Access Compliance Report

Public Rights-of-Way

(Curb Ramps)

Intersection ID: 46733	Main Street: DARCY_HOPKINS_DR	Cross Street: BEAVER_BROOK_WY	Location: SW
ADA ID: 463180A1ADD0	Ramp Type: PerpDiag	Initial Pass/Fail: Fail	Overall Compliance: No
Severity Score: 10			
Codes/Mitigation Info/Possible Solution		Field Measurements/Component Compliance

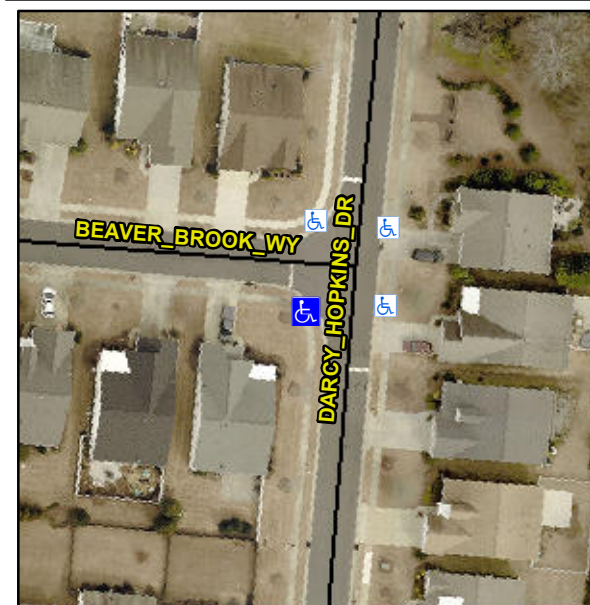
Not Found, R304.5.1, R304.5.3

Compliance	Description	Data	Compliance	Description	Data
N/A	Ramp Length (in)	46.0	Yes	Ramp Slope (%)	7.8
No	Ramp Width (in)	44.0	No	Ramp XSlope (%)	2.6
N/A	Flare Type LT	N/A	N/A	Flare Type RT	N/A
N/A	Flare Slope LT (%)	N/A	N/A	Flare Slope RT (%)	N/A
N/A	Flare Traversable LT?	N/A	N/A	Flare Traversable RT?	N/A
N/A	Landing Length (in)	N/A	N/A	DWS Provided?	N/A
N/A	Landing Width (in)	N/A	N/A	DWS Contrast?	N/A
N/A	Landing Slope (%)	N/A	N/A	DWS Length (in)	N/A
N/A	Landing X Slope (%)	N/A	N/A	DWS Full Width?	N/A
N/A	Landing Curb? (Y/N)	N/A	N/A	DWS Offset (in)	N/A
N/A	Shared Landing?	N/A			
N/A	Gutter Ponding?	N/A	N/A	Gutter Slope (%)	N/A
N/A	Gutter Lip Ht (in)	N/A	N/A	Gutter X Slope (%)	N/A
N/A	Painted X Walk1?	No	N/A	Painted X Walk2?	No
	X Walk 1 Direction	To SE		X Walk 2 Direction	To NE
N/A	X Walk 1 Width (in)	N/A	N/A	X Walk 2 Width (in)	N/A
	X Walk 1 Slope (%)	1.2		X Walk 2 Slope (%)	2.3
	X Walk 1 X Slope (%)	1.9		X Walk 2 X Slope (%)	0.9

Remove & Replace Curb Ramp With Two New Directional Ramps or Equivalent.
